STAFF REPORT: 5/14/2025 MEETING

ADDRESS: 2044 CHICAGO

APPLICATION NO: HDC2024-00199

SCOPE: REPLACE WINDOWS AND REBUILD 2nd AND 3RD STORY

Photo taken in early 2018, prior to the fire. Note that all windows at the front are wood casement windows with leaded glass. The windows at the second story are covered by aluminum windows. Source, HDC files

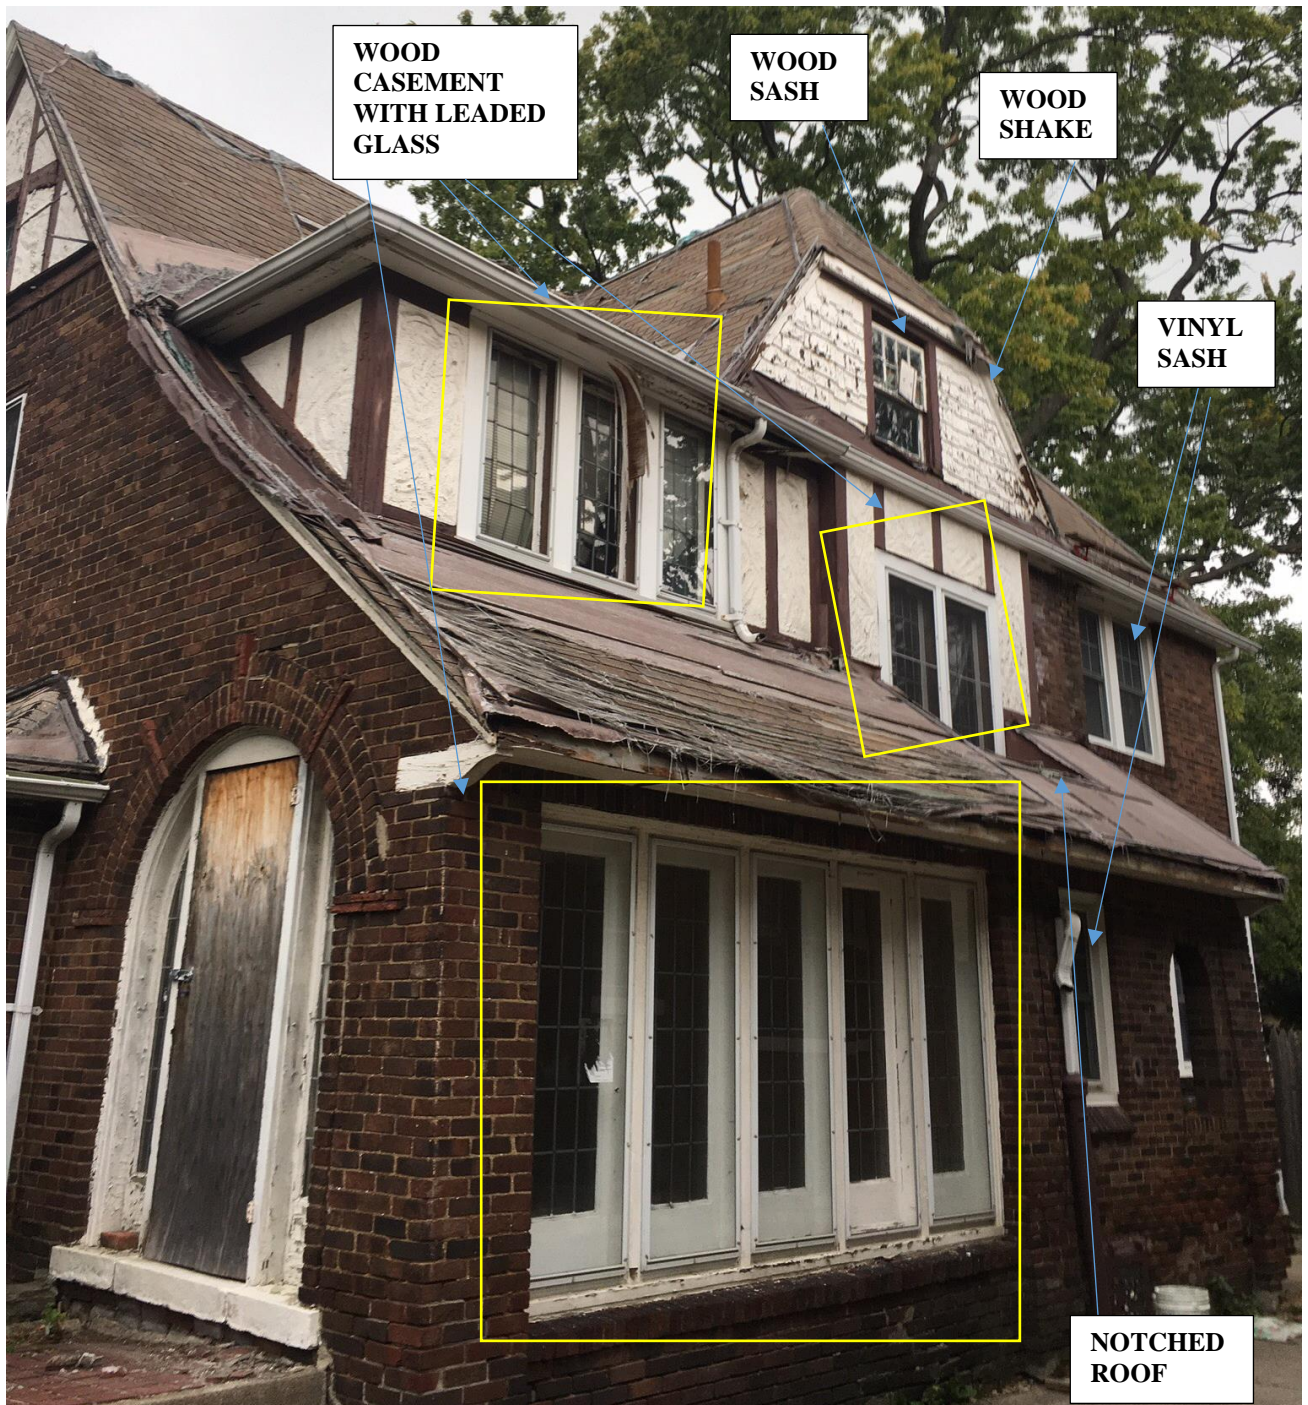
- After a review of available images and photos (see above annotated photos), it is staff’s opinion that the fire completely destroyed all of the second and third story windows. Also, staff determined that the following non-historic, incompatible windows were extant prior to the fire. These were likely the eight vinyl windows that the Commission approved in 2018:
 - A pair of vinyl double hung windows at the east wall, second story
 - A single vinyl double hung windows at the east wall, first story
 - A pair of vinyl double hung windows at the rear, second story
 - A vinyl slider window at the first story, rear wall
 - A 1/1, single hung vinyl window at the first story, rear wall

- Staff does note that the recent removal of the historic wood casement windows with lead coming and associated trim at the west wall, first story; the leaded glass windows at the first story, front façade; and the leaded glass sidelites at the front door, first story does not meet the Standards as they appear to have been in good condition. As such, the scope items related to their replacement are not appropriate as the Standards require the original units to have been retained and repaired in kind where necessary. However, as these elements are no longer extant and new units must be installed in these openings, staff notes the following regarding the current application:
